PHOTOGRAPHS

PHOTOGRAPH #29

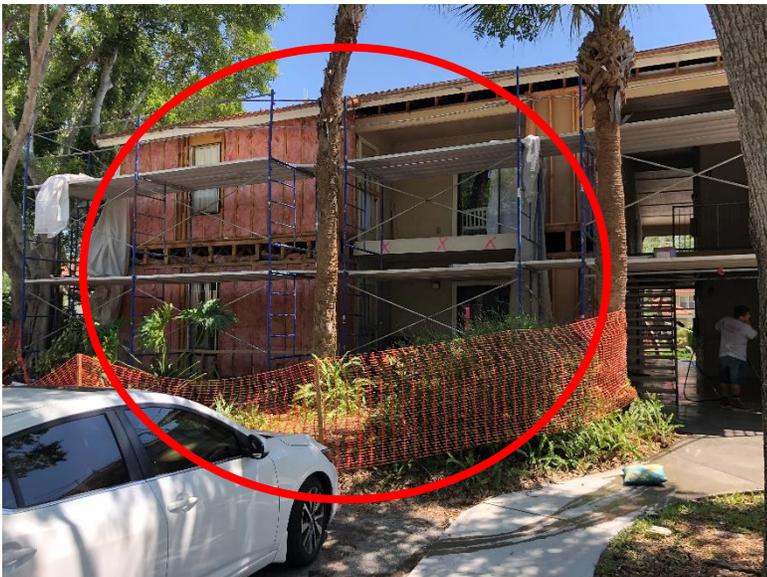
Termite damaged wood framing at breezeway marked for repairs.
